FEBRUARY 2020

PL6

NON MATERIAL  
AMENDMENT  
PLANNING  
APPLICATION  
& CONDITION 4  
DISCHARGE

44 A GLOUCESTER  
AVENUE LONDON  
NW1 8JD

# 2.4 CHANGES TO CONSENTED DEMOLITION FRONT ELEVATION

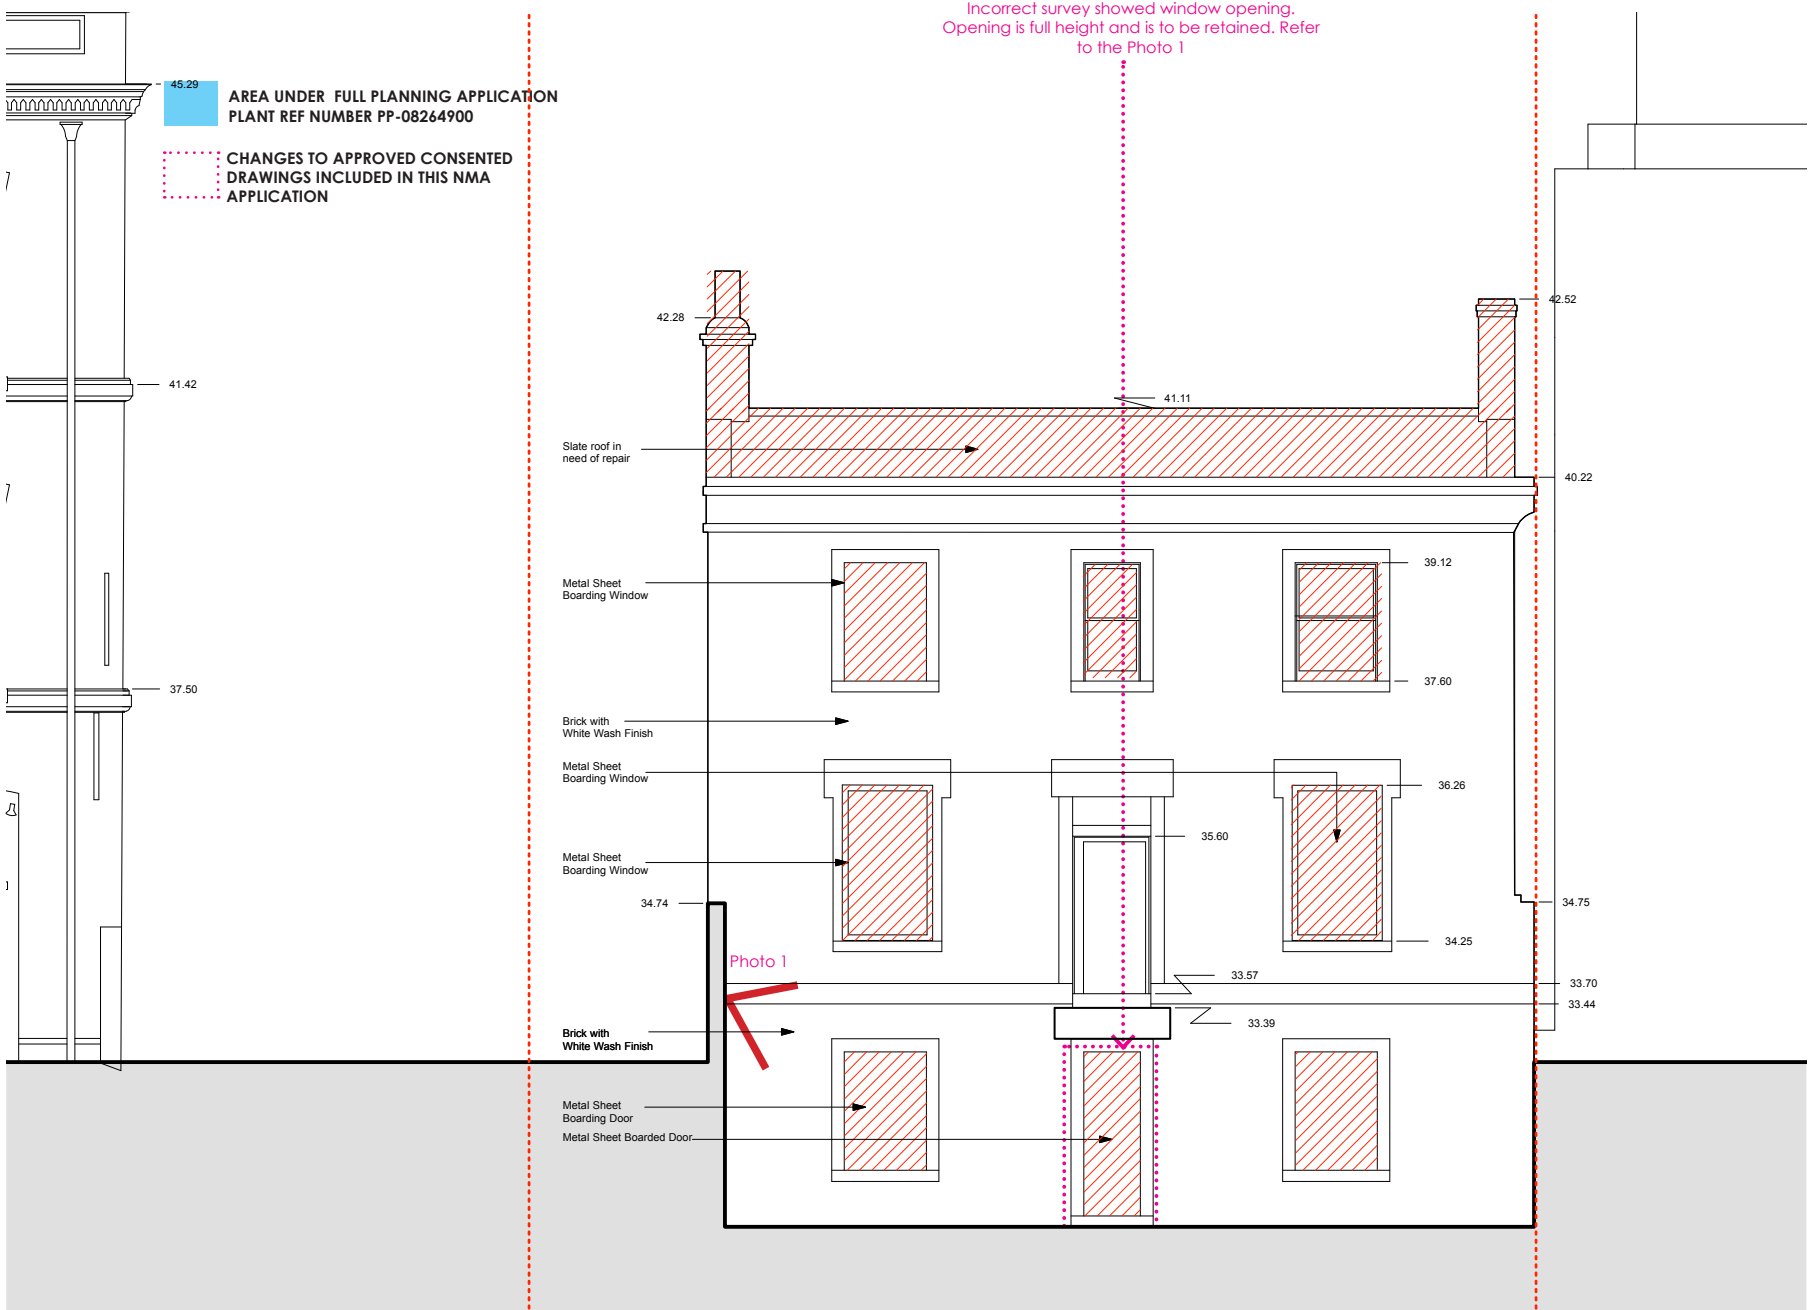
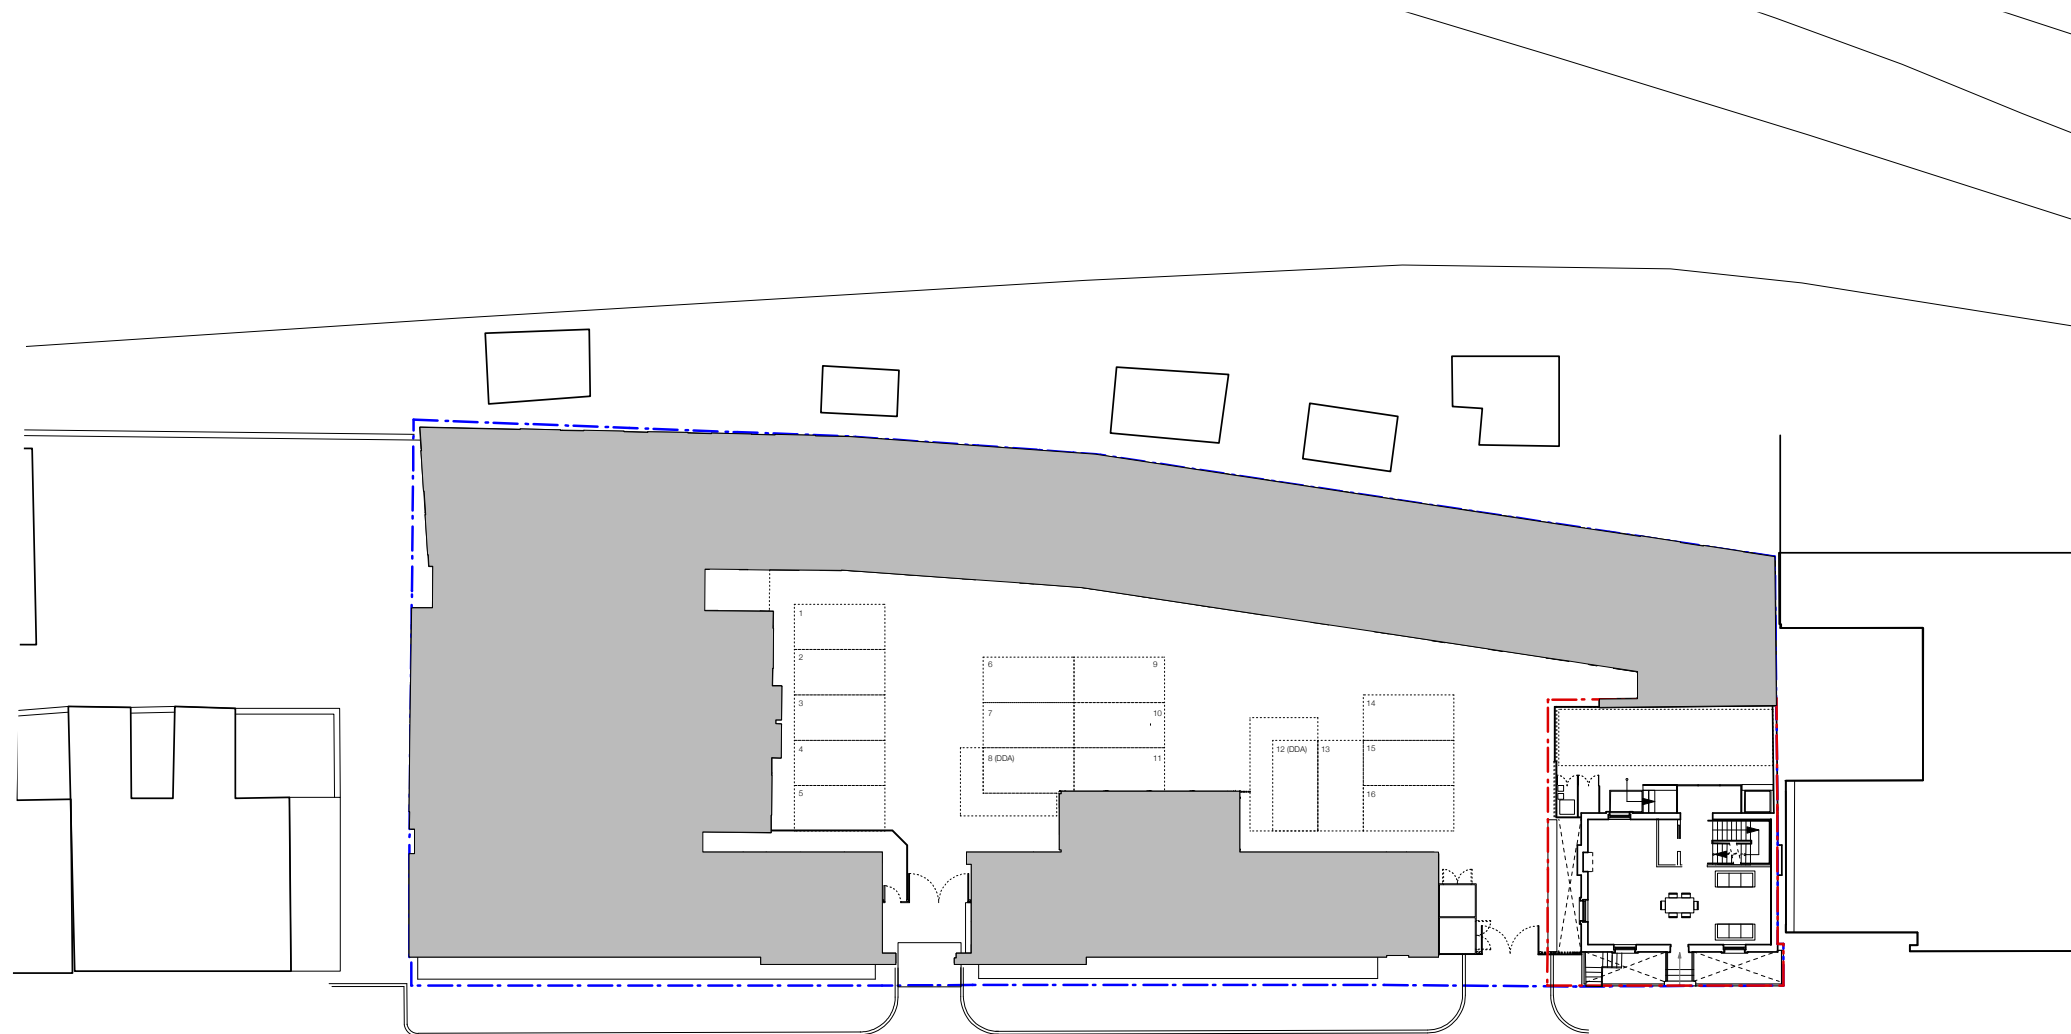
- Due to incorrect initial survey basement front balcony opening has been revised in the demolition drawings
  - Demolition drawings have been revised with correct openings in the side elevation and other minor changes

PHOTO 1. PHOTO OF THE EXISTING FULL HEIGHT OPENING

## 2.5 CHANGES TO CONSENTED BLOCK PLAN

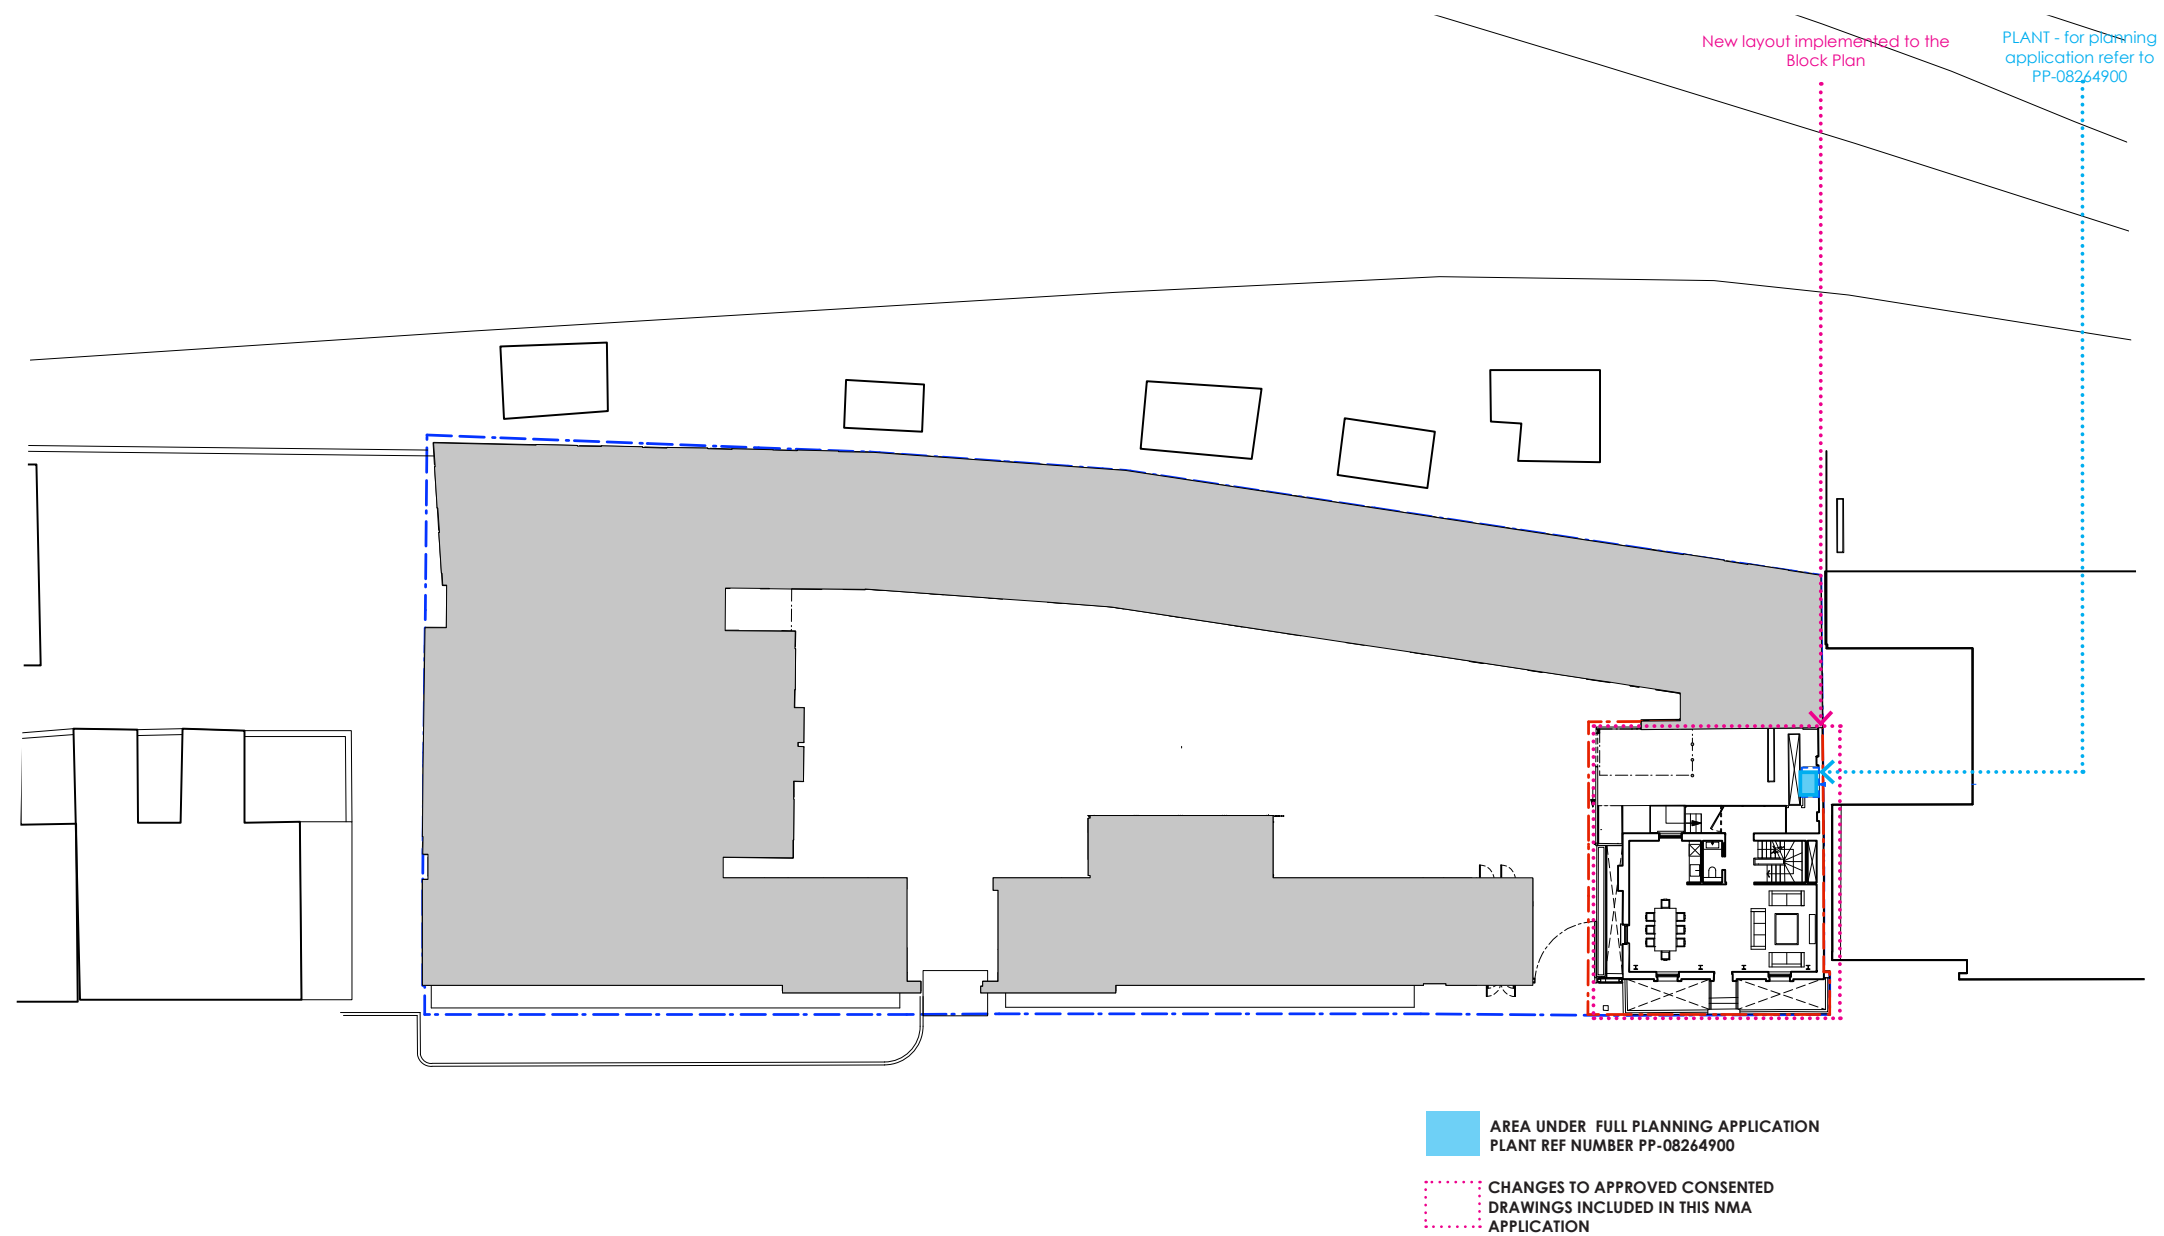
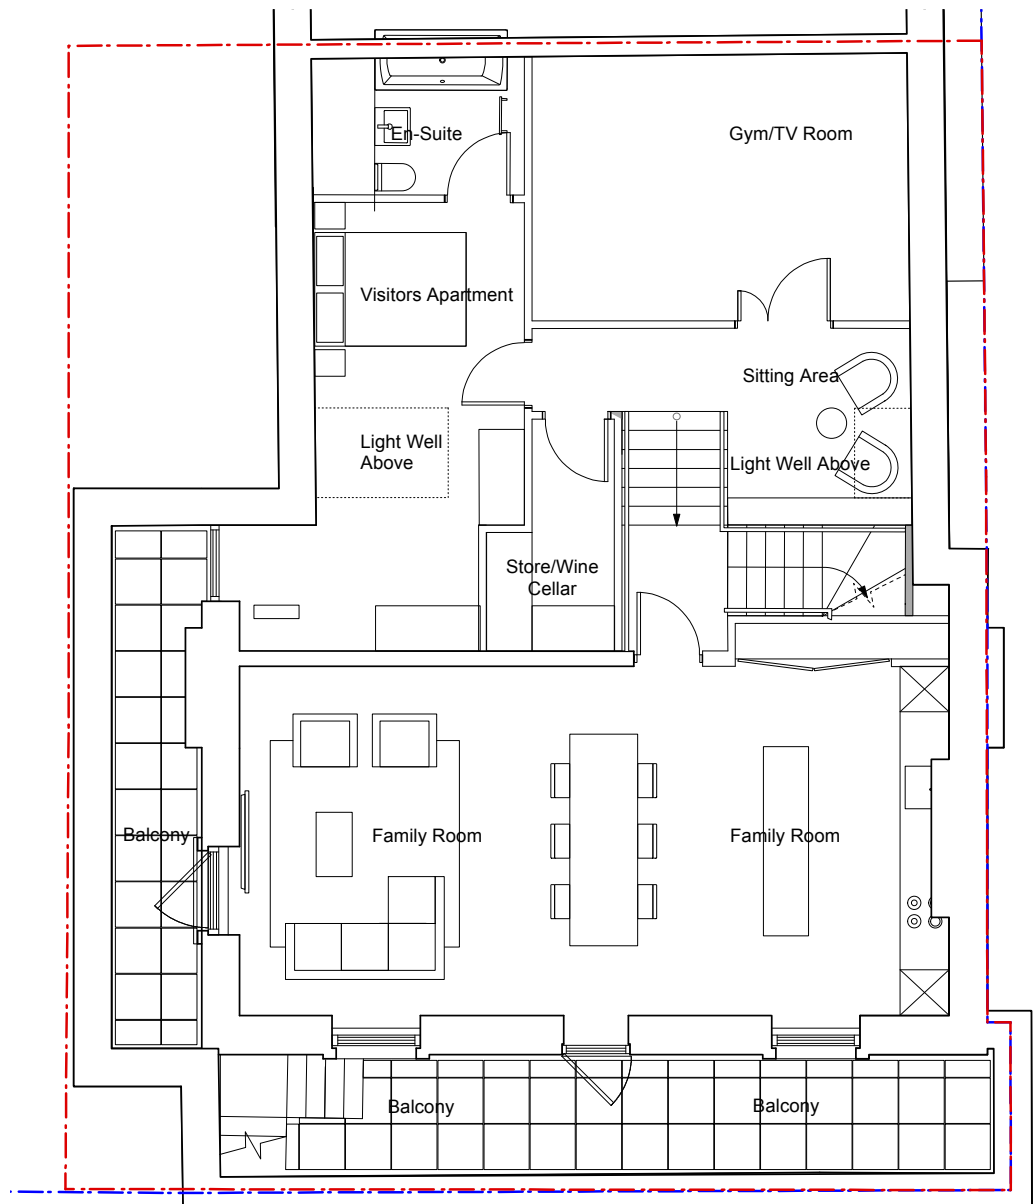
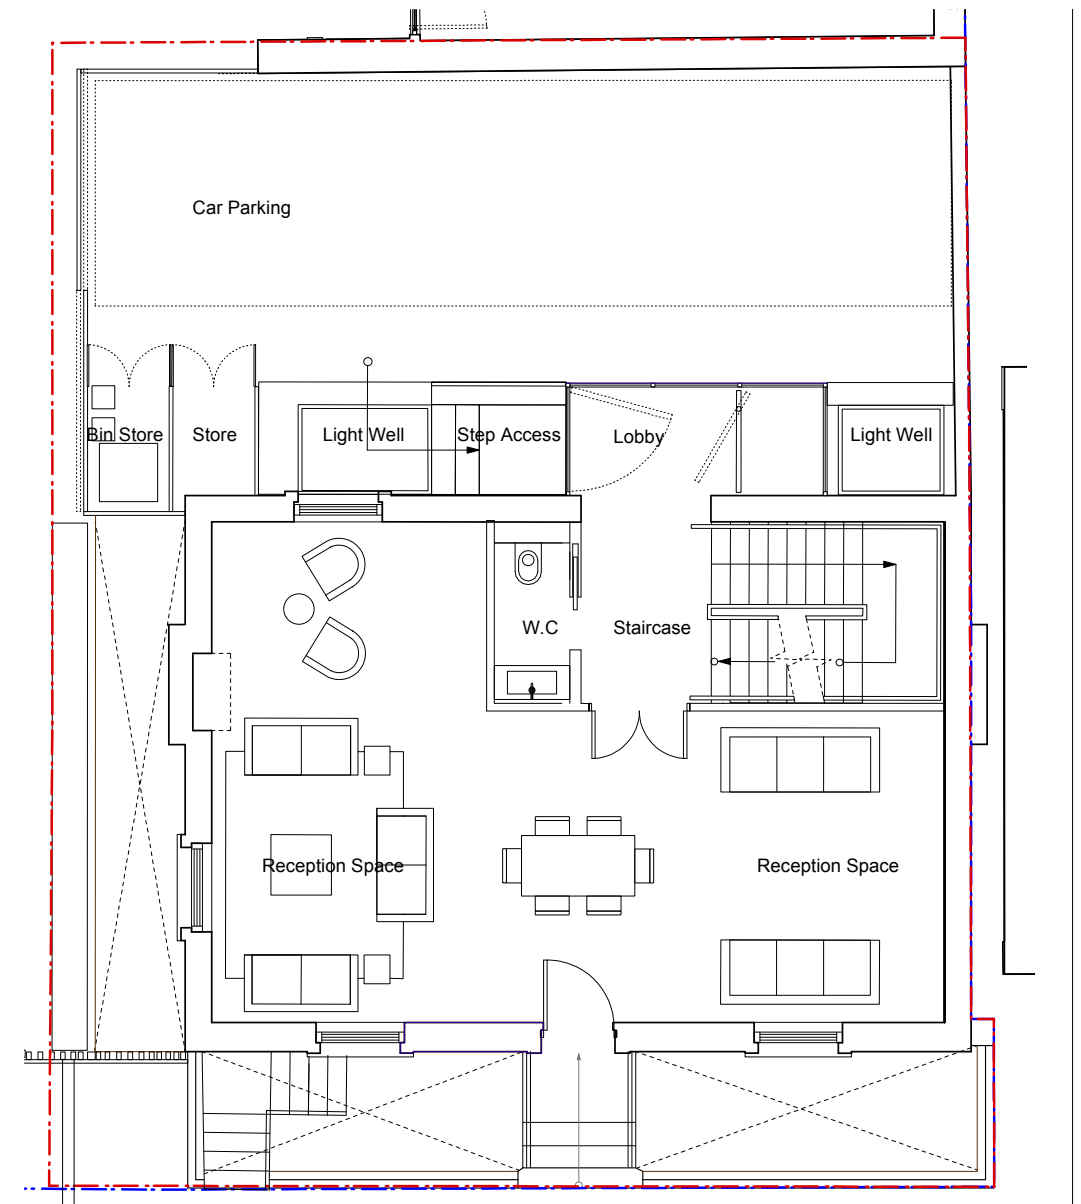
- Side basement balcony to have single door access
  - Approved store modified to cycle store, bin store relocated to rear of the courtyard and the base of the lightwell extended to the edge of the house

- Planters have been placed in the rear courtyard
  - Lightwell relocation and change in plan to adapt to new layout
  - Bollards have been added to the parking space to the rear courtyard. Specification for the pavers incorporated in the scheme

PROPOSED LANDSCAPE DRAWING

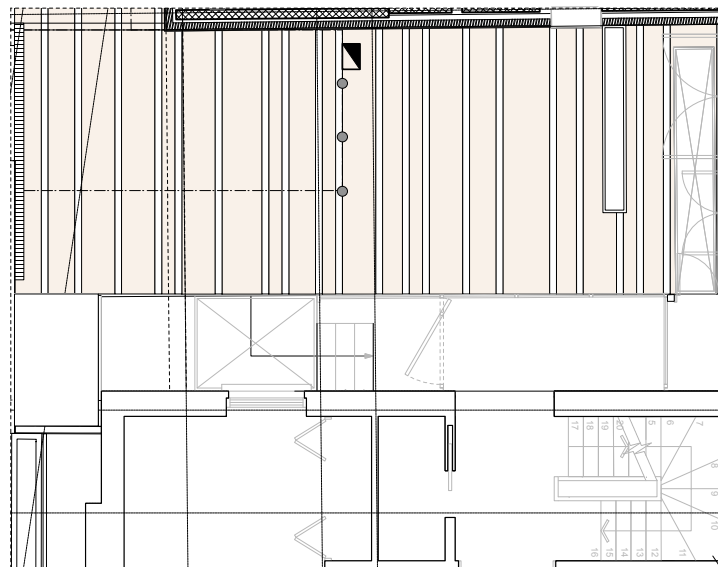
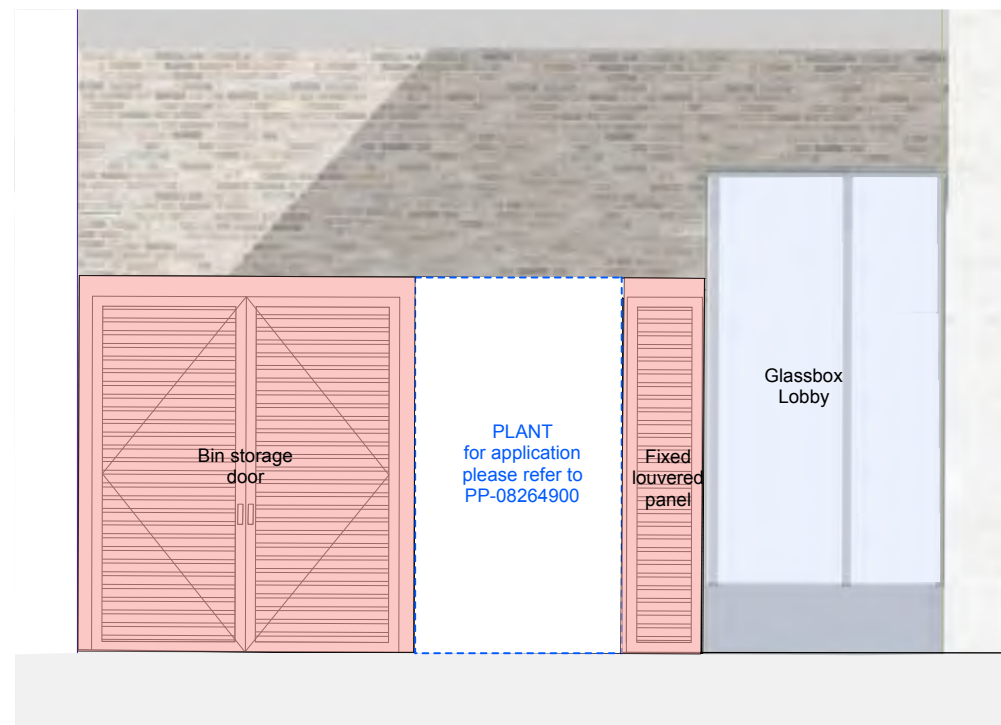
- 1.45 Planters have been placed in order to provide visual barrier to bin store. Existing approved store to be modified to cycle store.
- 1.46 Bollards to the car park have been added for safety measures
